Application Serial No. 10/734,219  
Amendment dated February 15, 2005  
Reply to Office action of November 22, 2004

REMARKS

Amendments to the Drawings:

Fig. 4

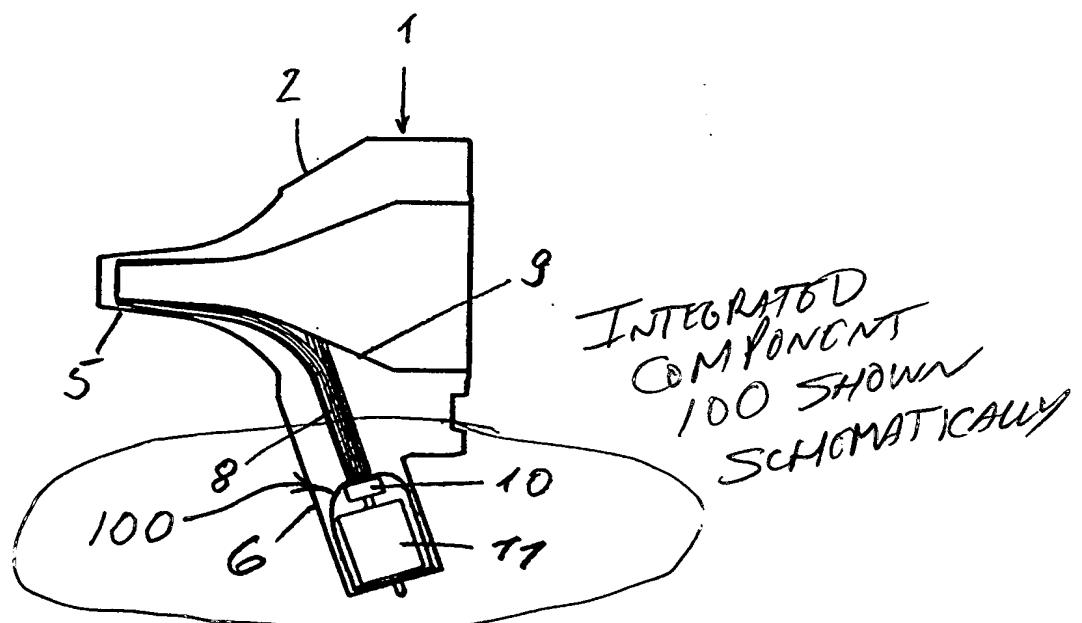
The attached two sheets of drawings include changes to Fig. 4. This Fig. 4 replaces the original Fig. 4. Integrated component 100 is now shown schematically in Fig. 4. This change to Fig. 4 merely comports Fig. 4 to paragraph [0010] of the specification as filed originally, as well as to claim 2. No new matter has been added.
